IS/18
dated --.--.2018

Information Message on PRANA Predictive Analytics and Remote Monitoring System

On --.--.2018, PRANA predictive analytics and remote monitoring system has detected deviation of HRSG (KUP-110/15-8.0/0.7-540/200 st. 1) technical condition in the control valve of high pressure tank (HPT) feeding (01HAC14AA902XJ117) during the period from --.--.2018.

Fig. 1. Throughput capacity and flow characteristics of the feed water CV

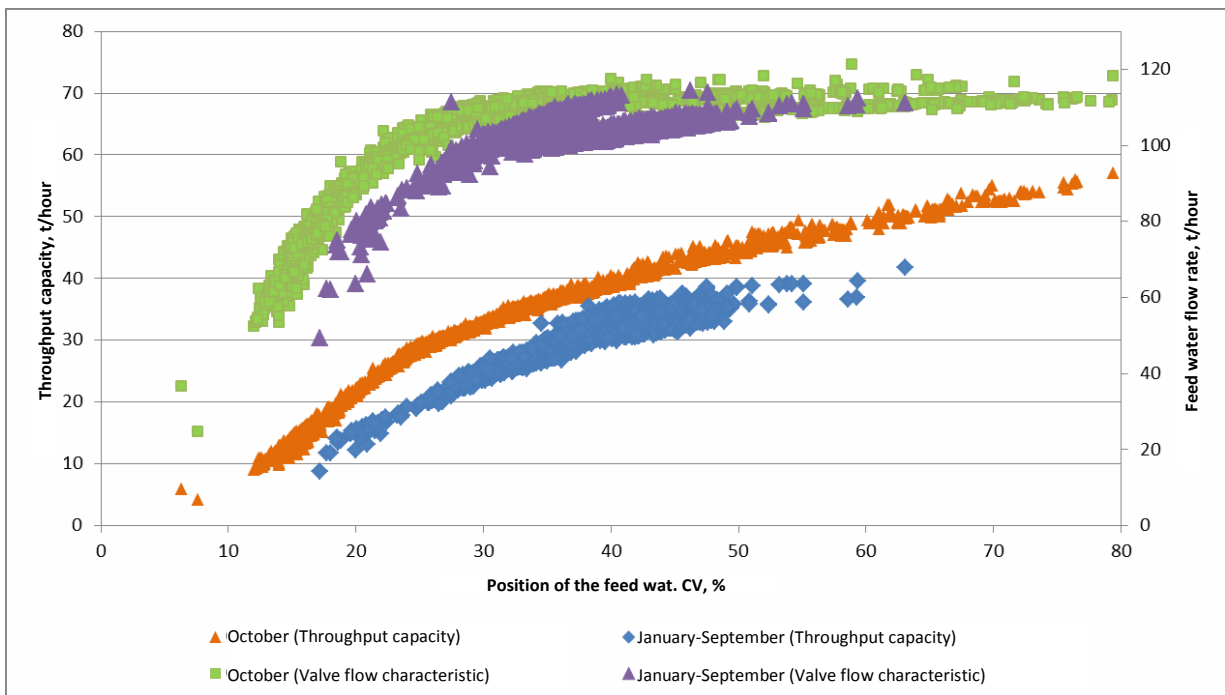
Observed change in the control valve throughput capacity (Fig. 1). This leads to the deterioration in the quality of level control in the drum.

The probable causes of detected deviation are:

1. Mechanical damages to HPT feed control valve.
2. PEN-1A (01LAC22CP001XJ116) head pressure drop due to the increase in the throughput of PEN-1A automatic spill-back valve.

It is recommended to:

1. Compare position at control valve location against the readings at control board WKS.
2. During the next planned shutdown, inspect the feed control valve in order to identify the causes of changes in throughput capacity.
3. During the next planned shutdown, inspect PEN - 1A automatic spill-back valve.
4. In order to improve the quality of recommendations, please provide feedback.
